Subject: Site Cleanup Program Case No. RO0003240 and GeoTracker Global ID T10000010203,
Amelia Street Redevelopment, 8410 Amelia Street, Oakland, CA 94621

Thank you for attending the meeting held at Alameda County Department of Environmental Health's (ACDEH) offices on June 8, 2018. The purpose of the meeting was to discuss the case status and identify the next steps to simultaneously facilitate site redevelopment and move the case to closure. ACDEH staff has reviewed the case file including the following documents prepared and submitted on your behalf by Pangea Environmental Services, Inc. (Pangea):

Attachment A - Pangea Figures with meeting mark-ups

Figure
2

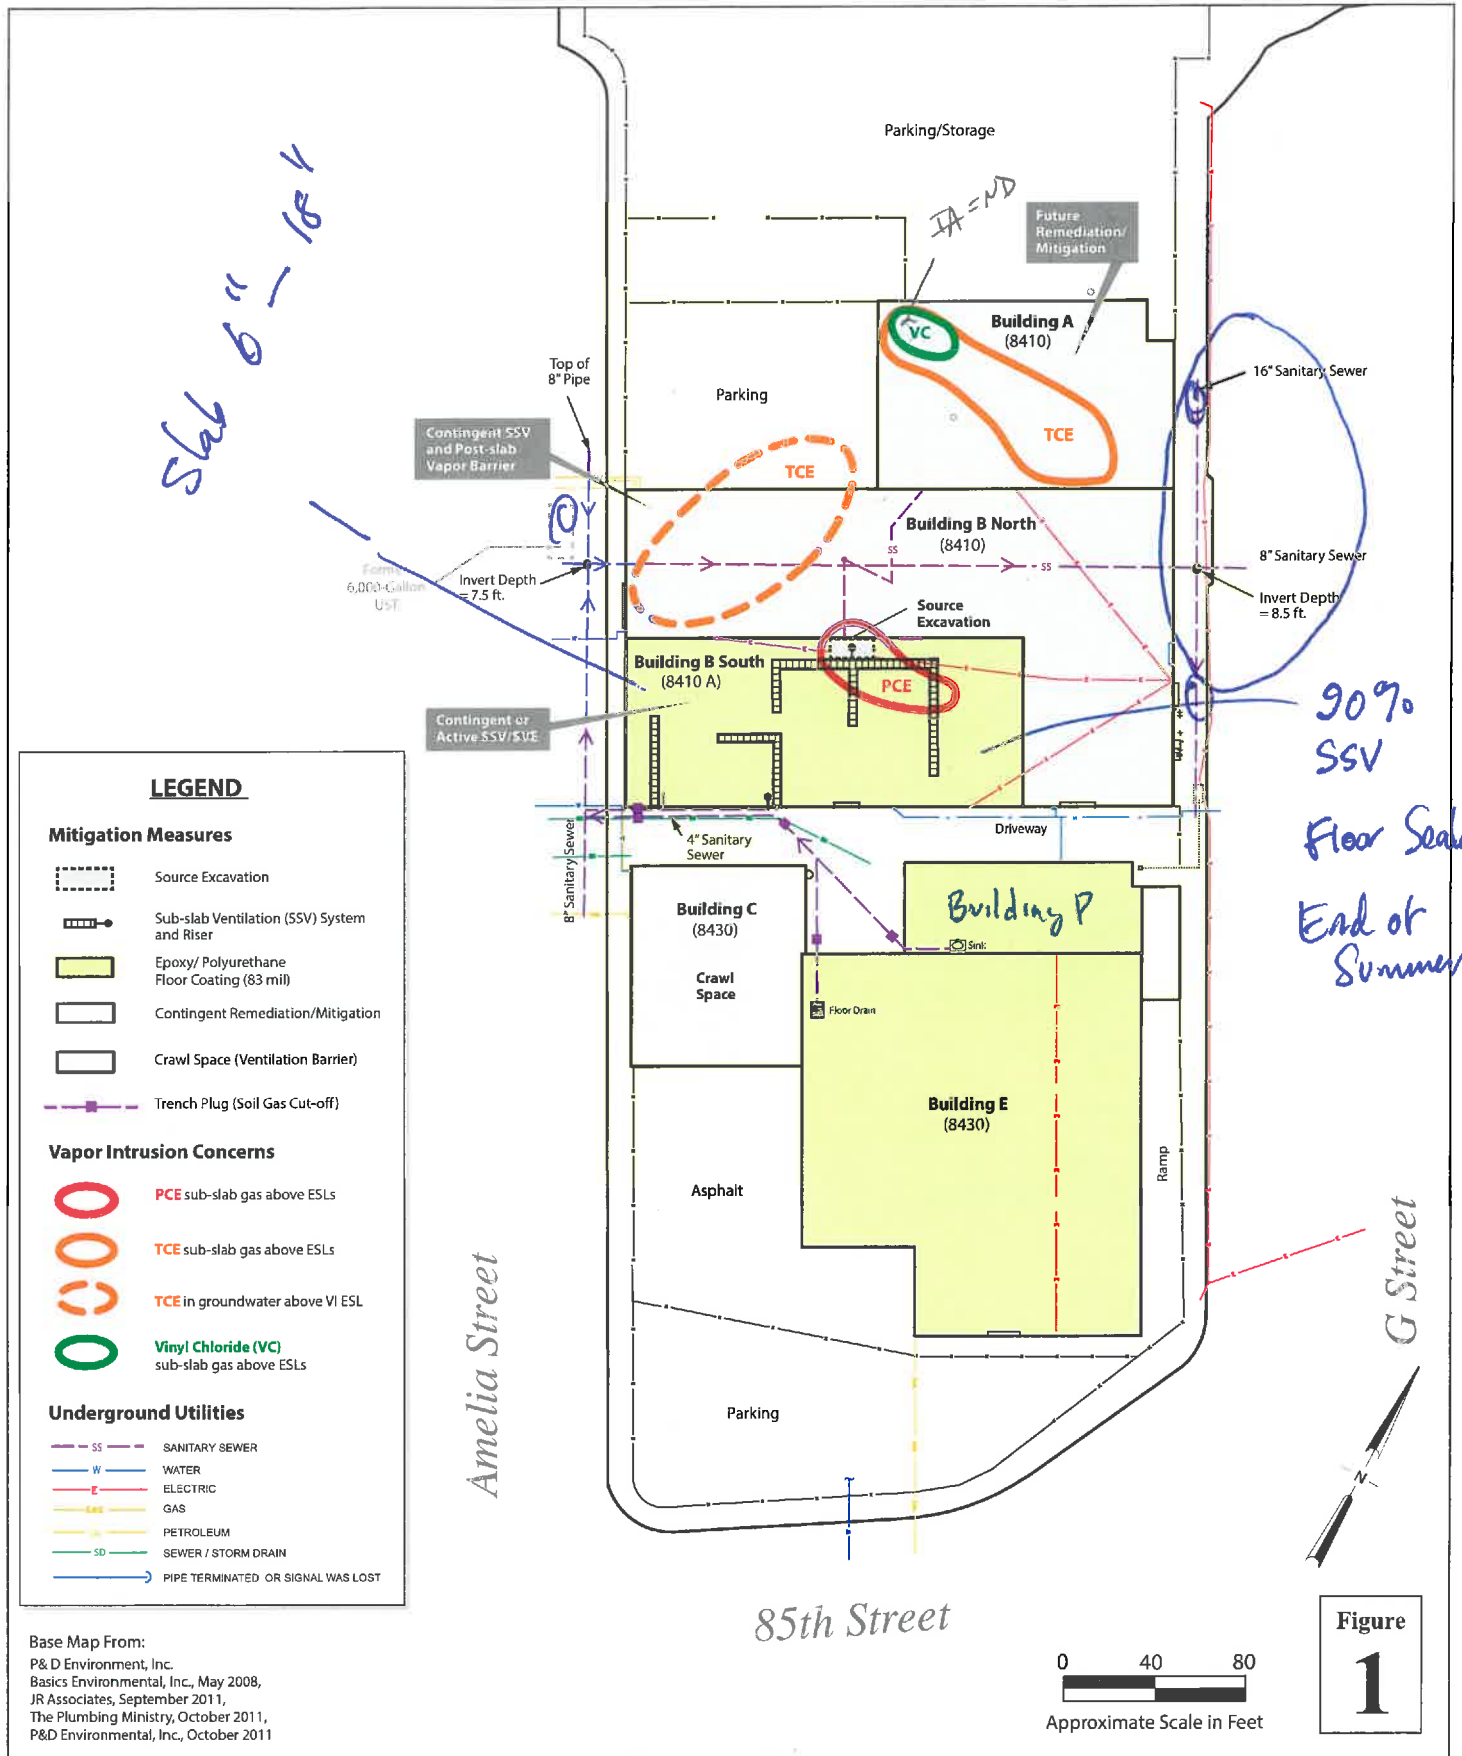
- Building B-South: The slab ventilation is 90% installed; Sewer lines are located 18-inches below the proposed vent piping.
 - Phase 1: 8430 Amelia Street: Amelia Street Ventures; need survey coordinates; epoxy not Retrocoat; voluntary improvements;
 - Phase 2: Building B South; in construction – end of year;
 - Phase 3: Building B North – NIMBY; tenant lease is up at the end of the year
- Depth to water on-site is approximately eight feet below ground surface (bgs)
- Soil and Groundwater Management Plan
- Health and Safety Plan

- As-built,
 - Surveyed trench;
- Building B-South:
 - Need Soil and Groundwater Management Plan;
 - Record Report of Construction with building permit;
 - Prior to occupancy, submit subslab, indoor air, and outdoor air sampling plan;

- Description of epoxy installation and bolt protocol sequencing;
- Building B-North – Improvements after tenant vacates;
- Offsite Source – K&L Plating, 989 89th Street, Oakland, (EPA Site ID CAD009183948)
